October 16, 2009

Subject: **Trenton, Acadia Welcome Center**
Federal Project No. 16123.50
State Pin No.016123.50
Amendment No. 2

SHEET NUMBER
A6.10
 OF

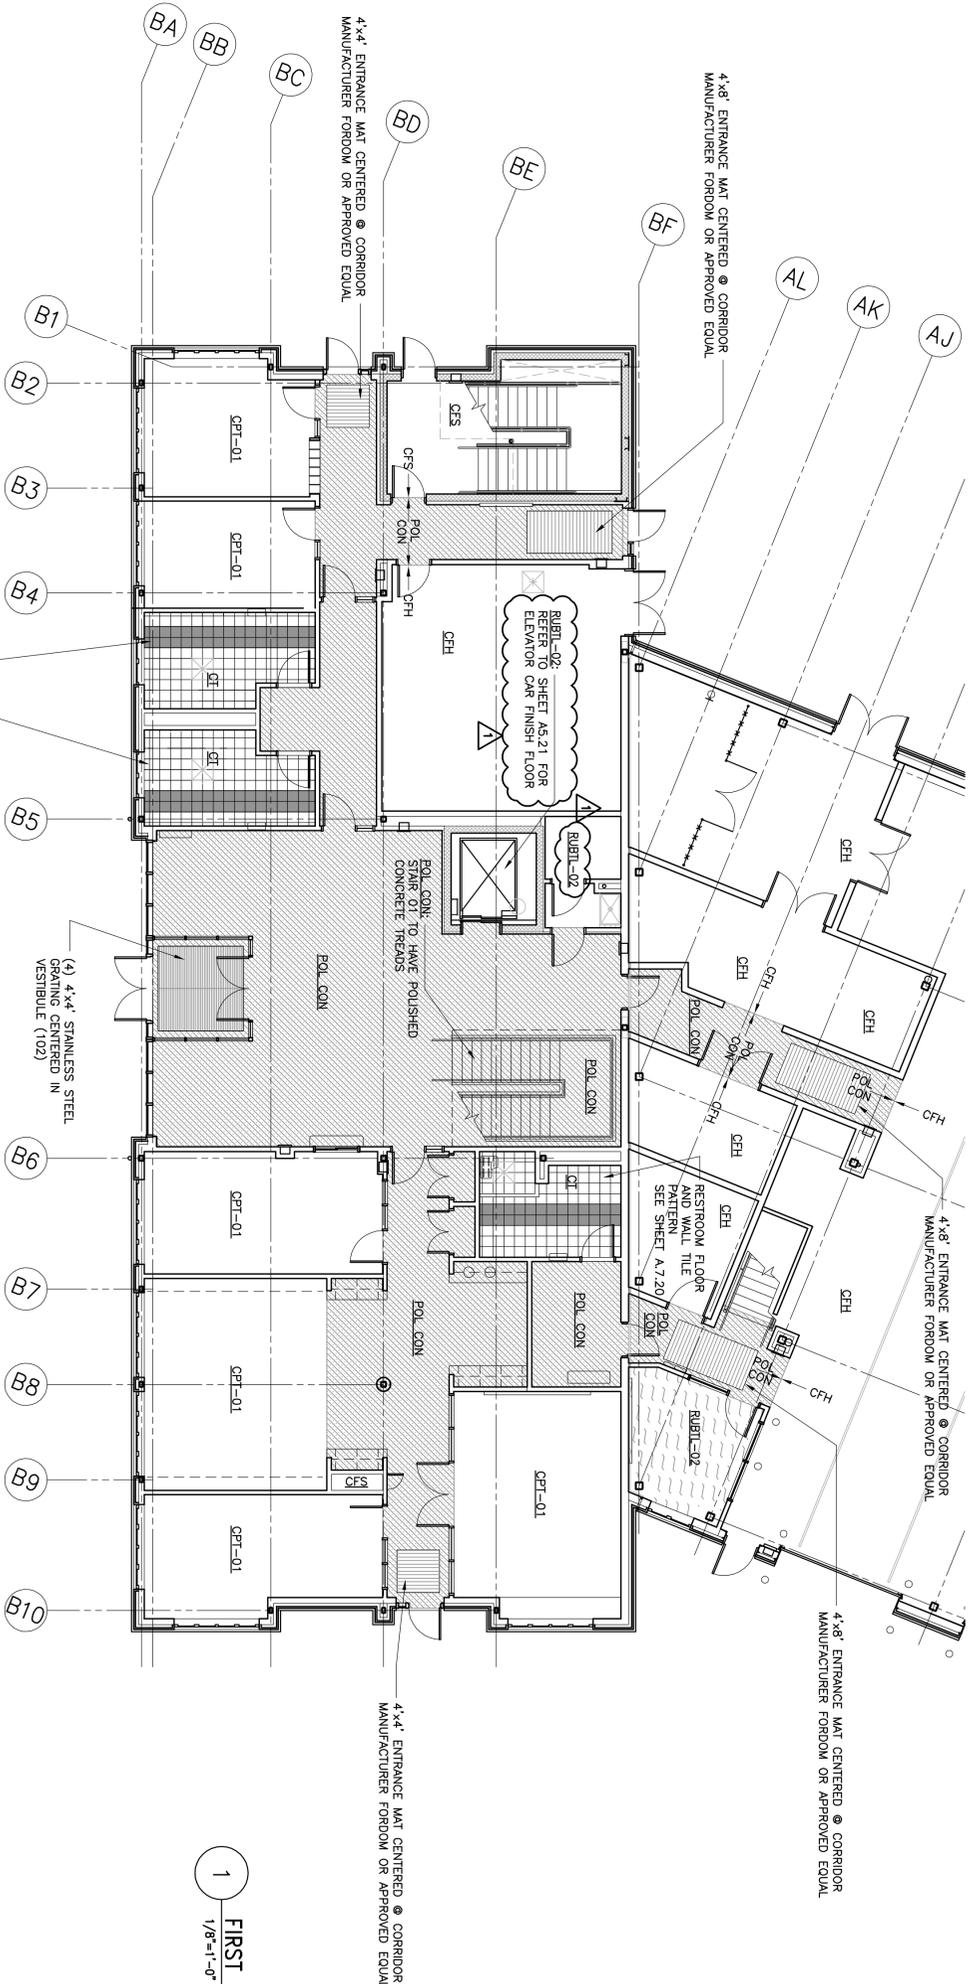
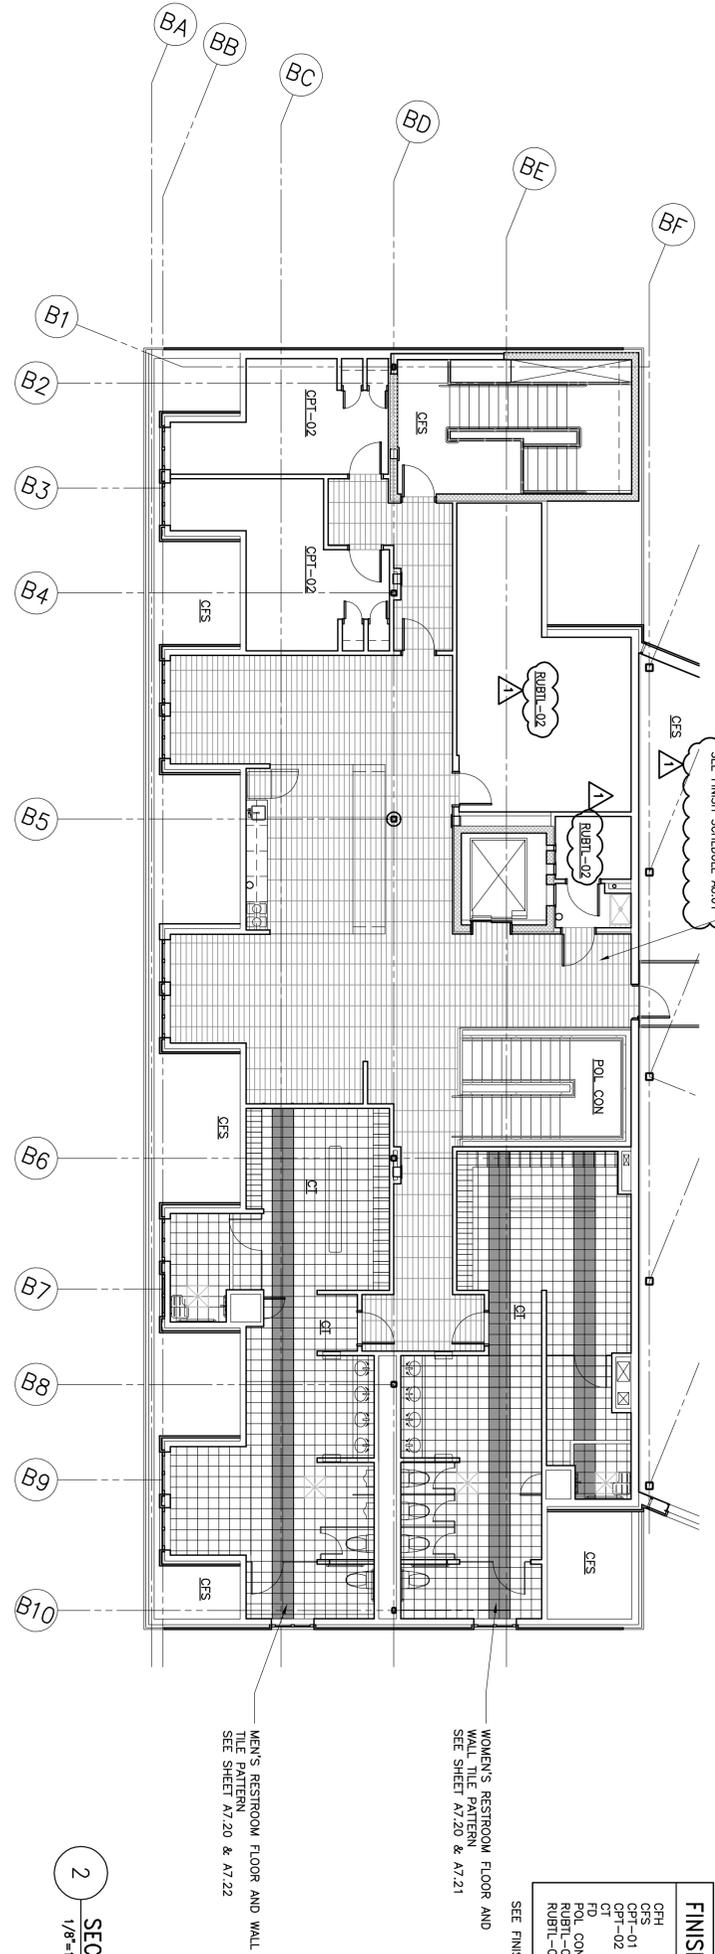
- A. **DELETE** Sheet A5.21 Elevator Car Details, in its entirety. **ADD** in its place, Sheet A 5.21 Elevator Car Details, attached.
- B. **DELETE** Sheet A6.10 Finish Floor Plans, in its entirety. **ADD** in its place, Sheet A6.10 Finish Floor Plans, attached.
- C. **DELETE** Sheet A7.04 1ST Floor Enlarged Plan IV, in its entirety. **ADD** in its place, A7.04 1ST Floor Enlarged Plan IV, attached.

1 ADMINISTRATION BUILDING FIRST FLOOR FURNITURE PLAN
1/4"=1'-0"

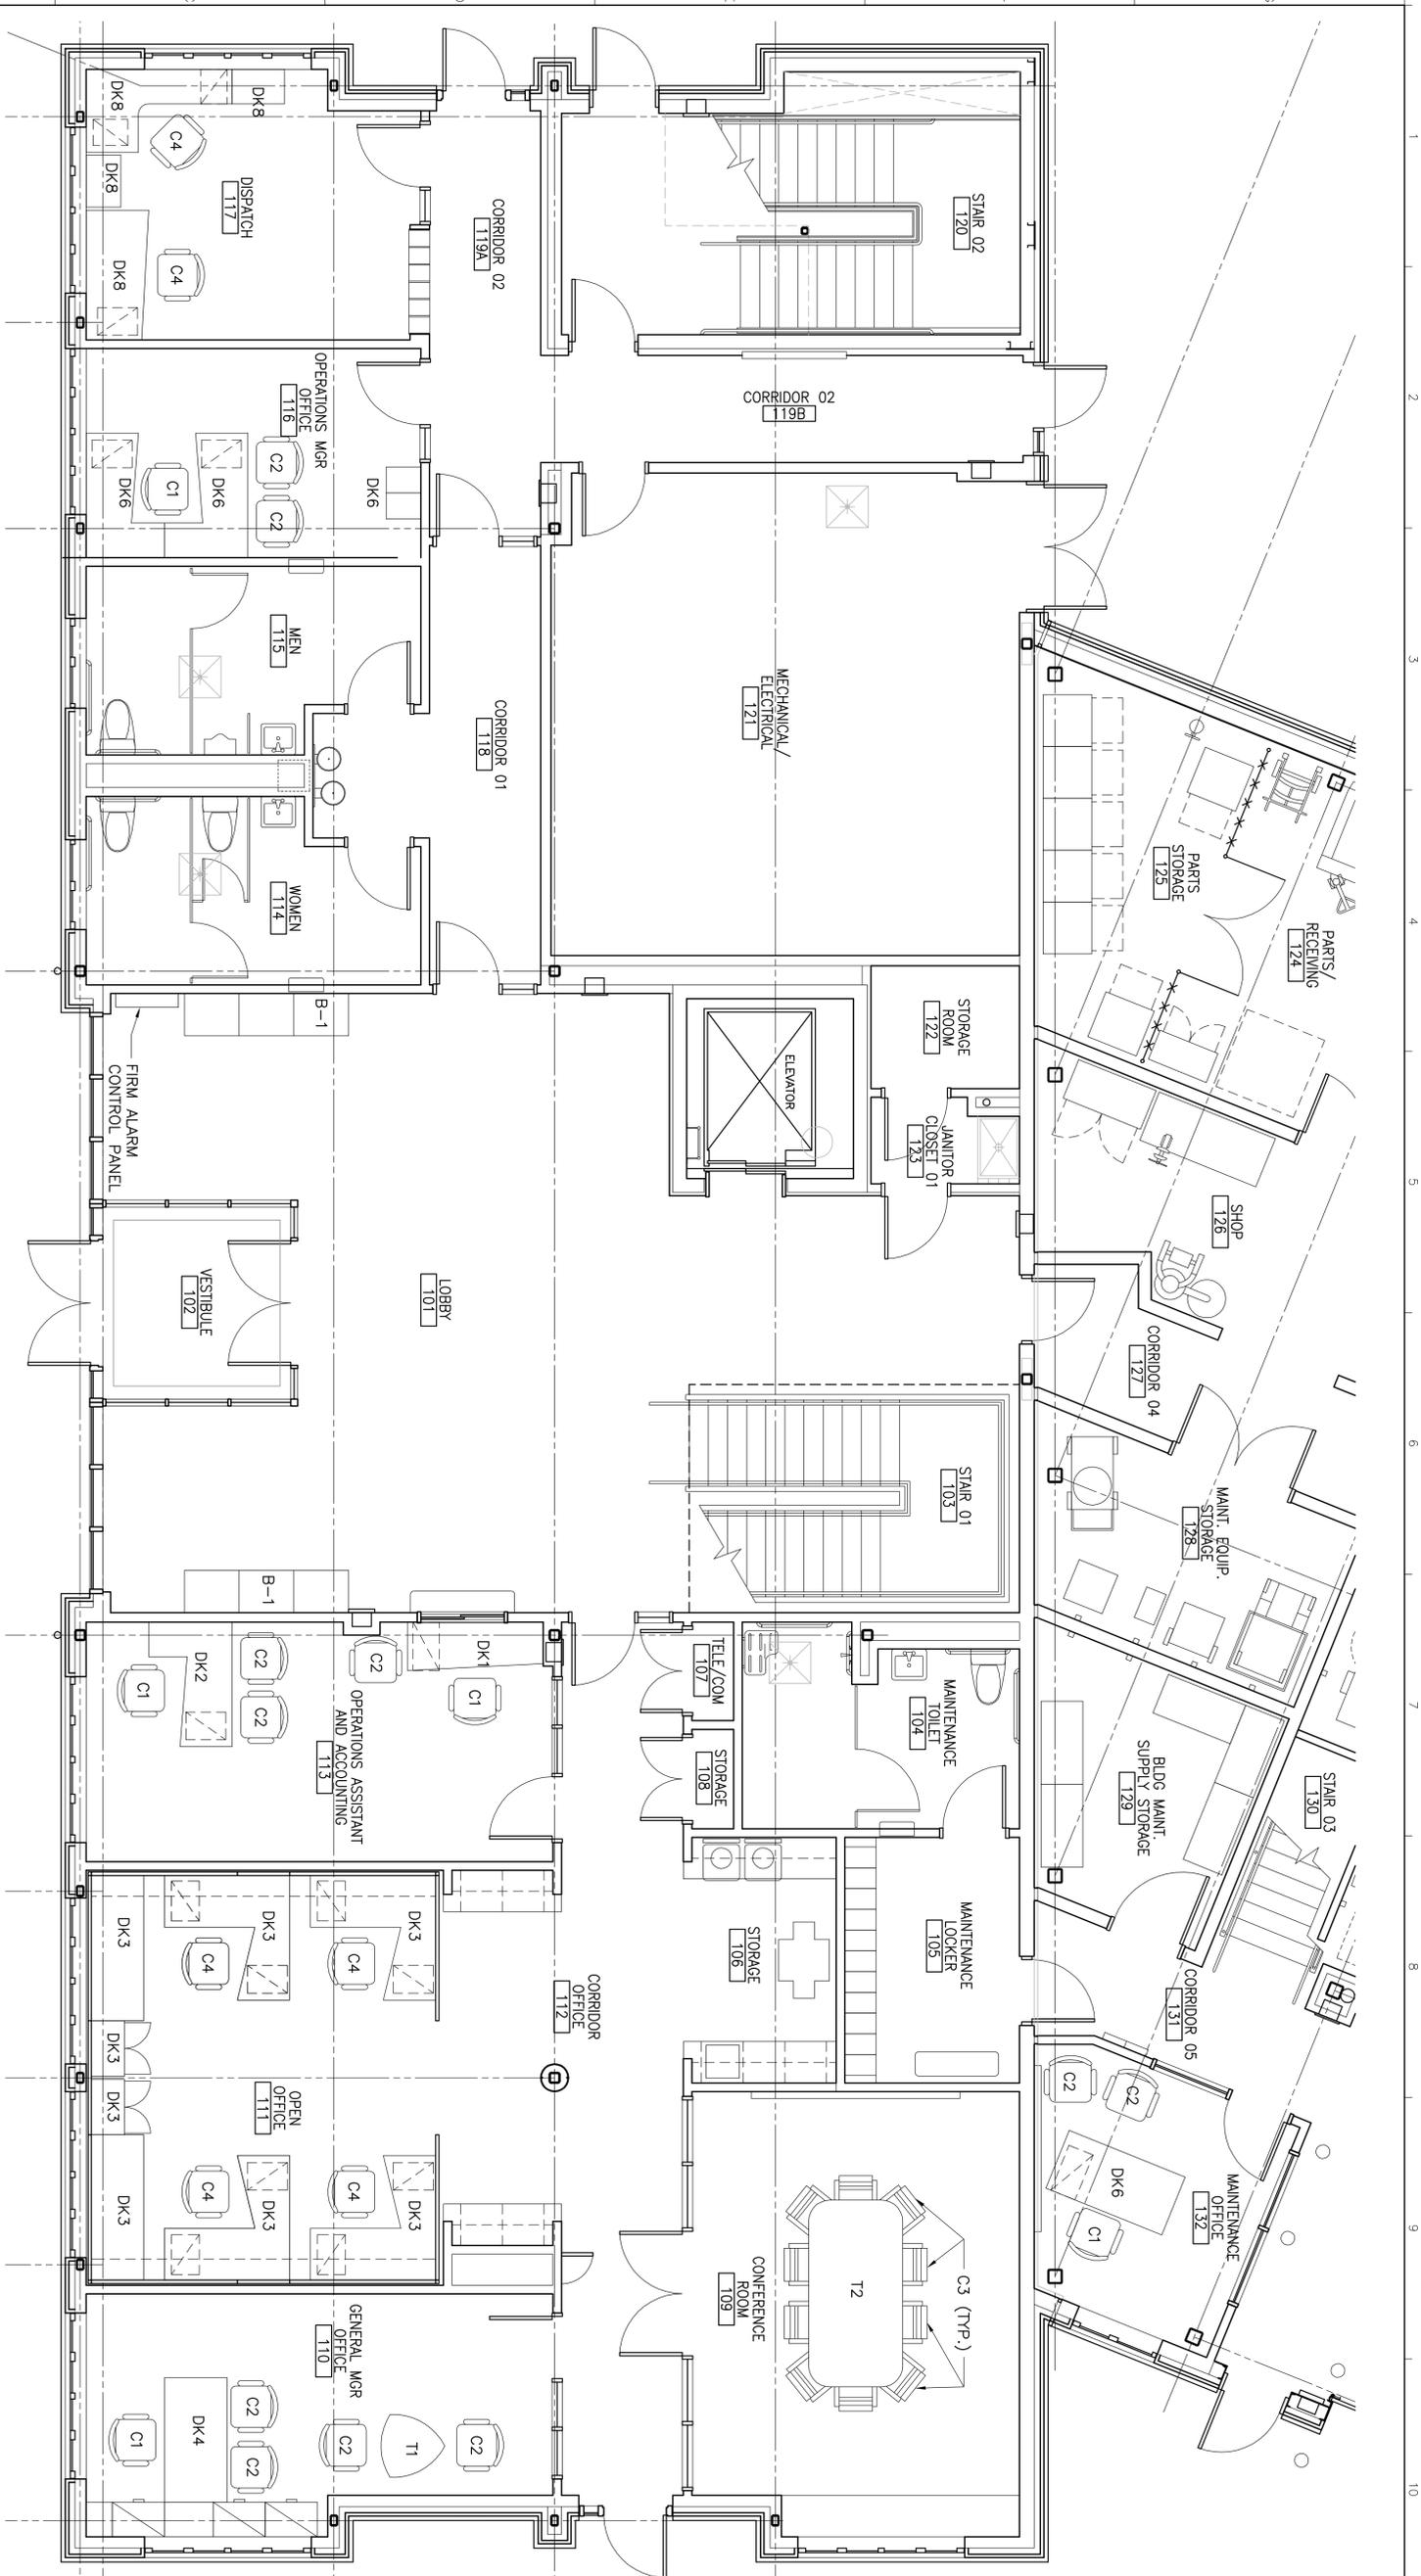
- D. **DELETE** Sheet A7.15 Administration Building First Floor Furniture Plan, in its entirety. **ADD** in its place, A7.15 Administration Building First Floor Furniture Plan, attached.

1 ADMINISTRATION BUILDING SECOND FLOOR FURNITURE PLAN
1/4"=1'-0"

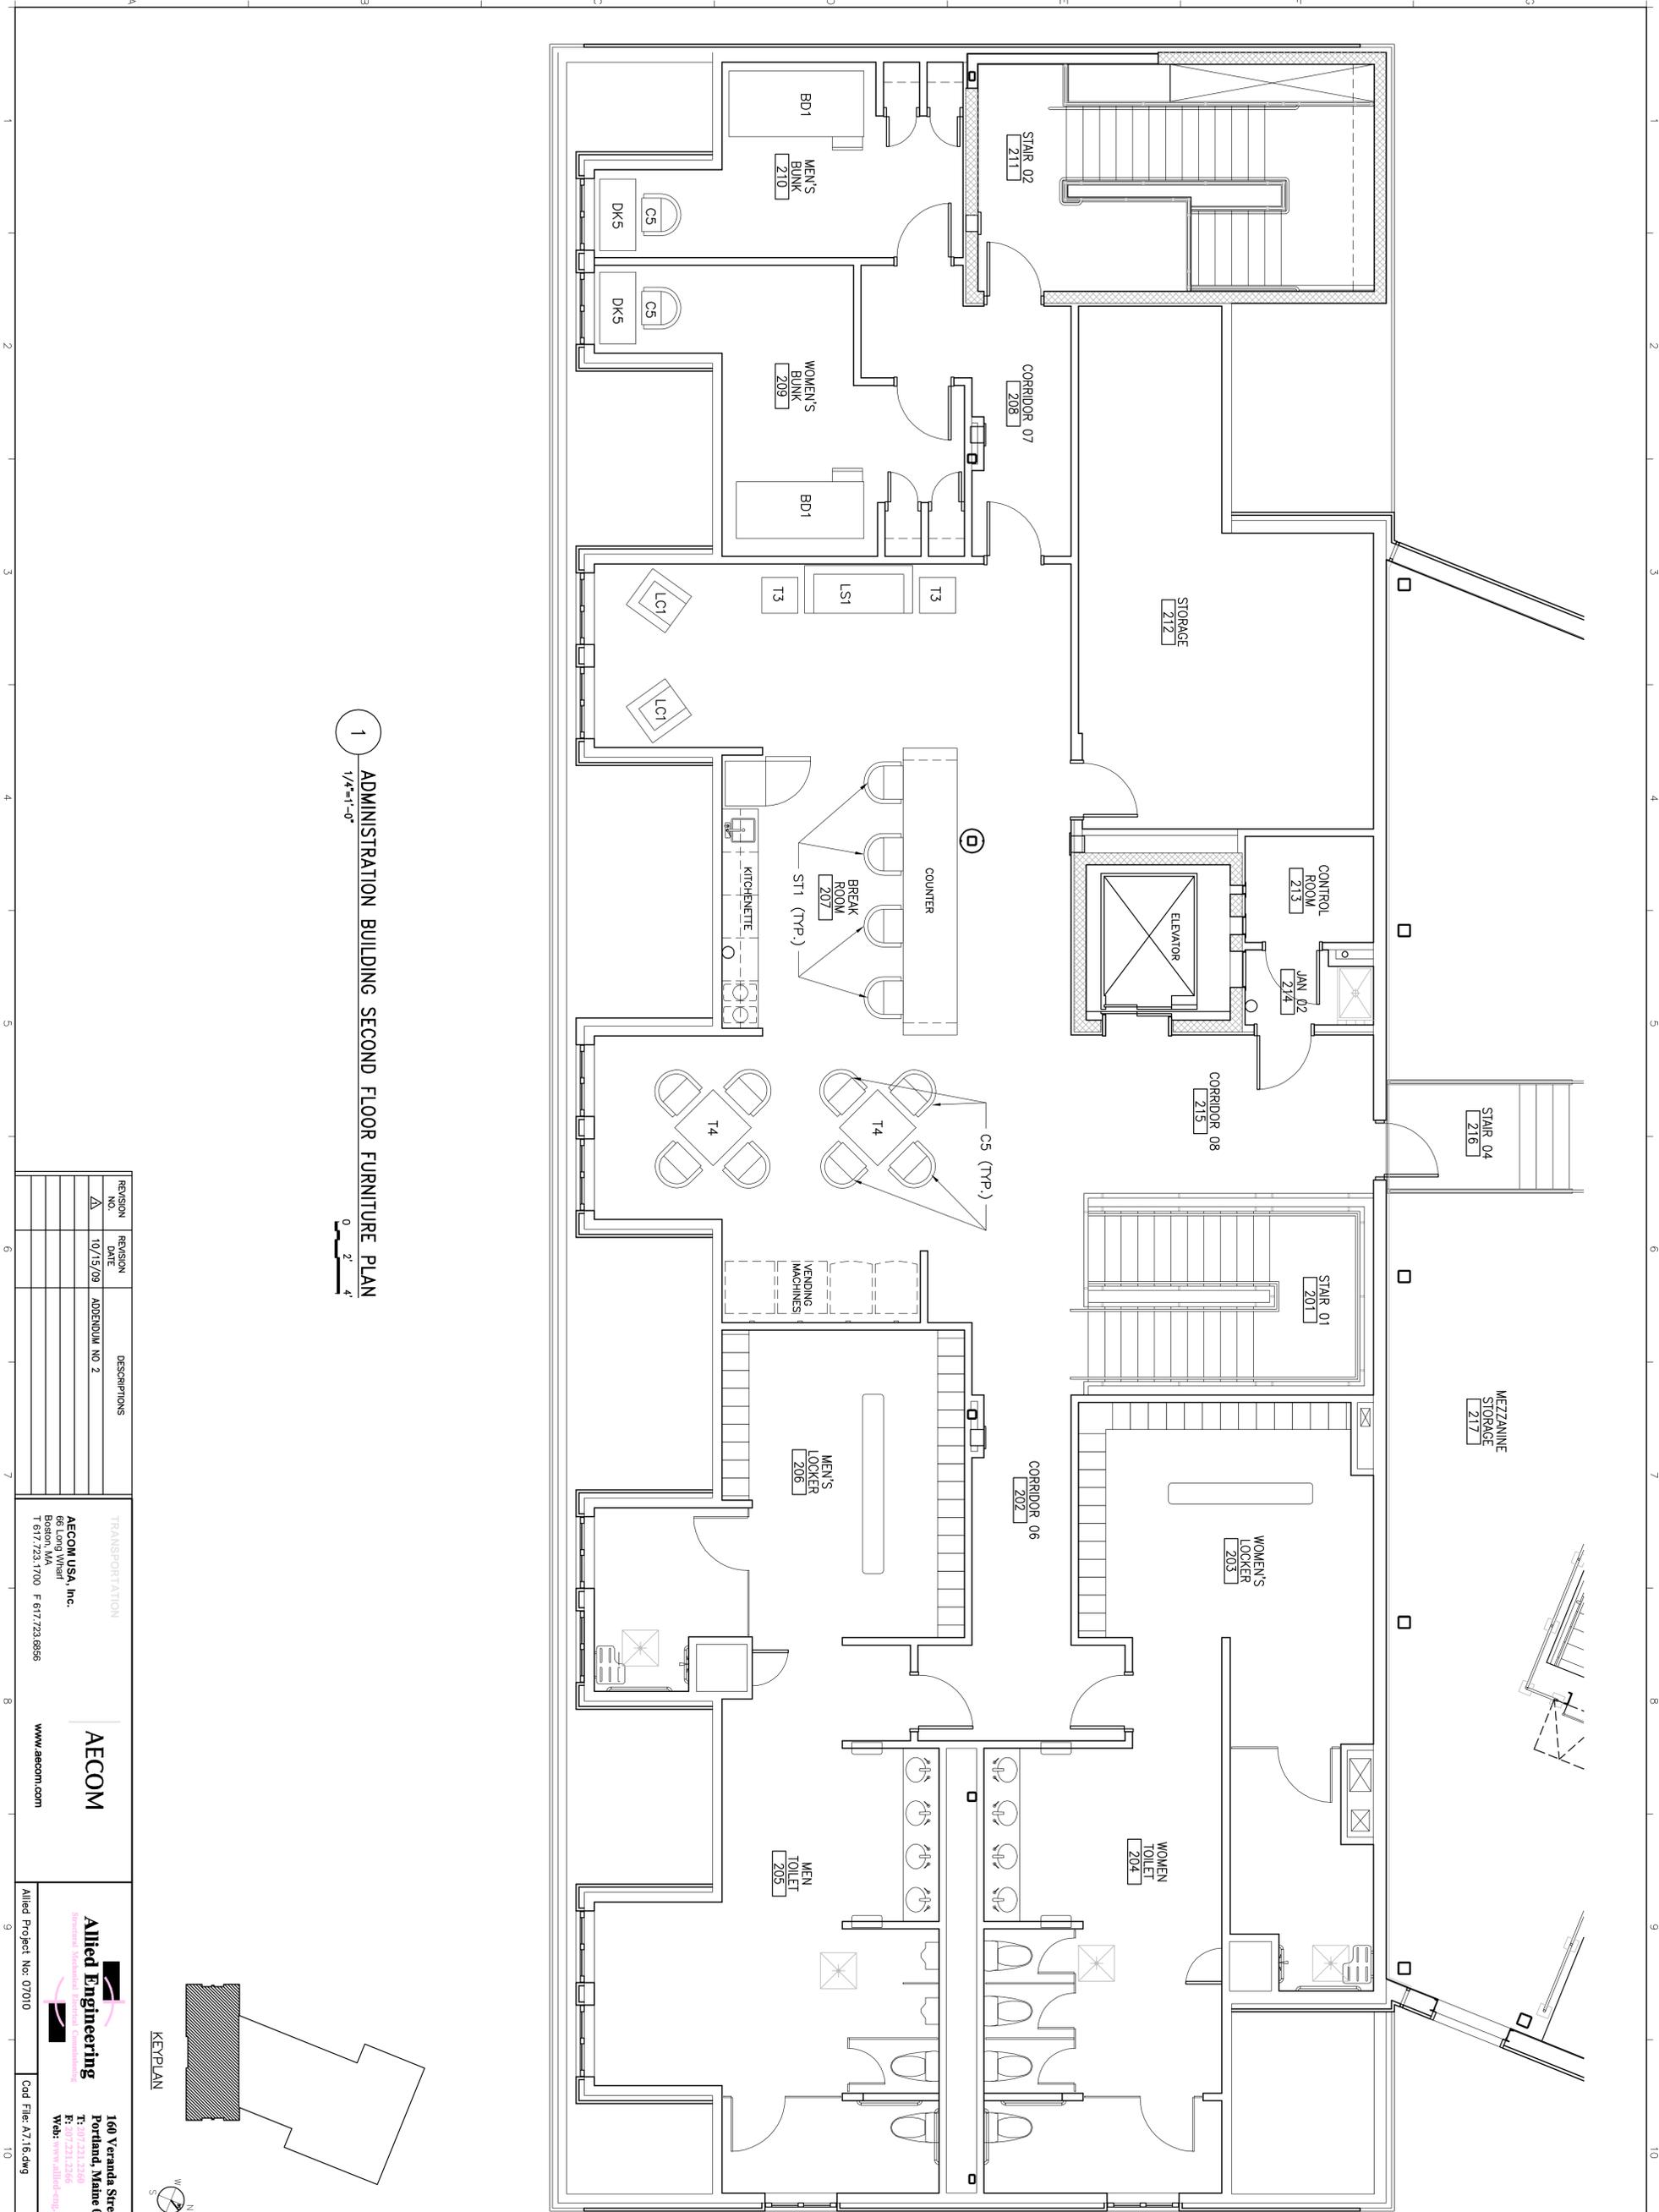
- E. **DELETE** Sheet A7.16 Administration Building Second Floor Furniture Plan, in its entirety. **ADD** in its place, A7.16 Administration Building Second Floor Furniture Plan, attached.
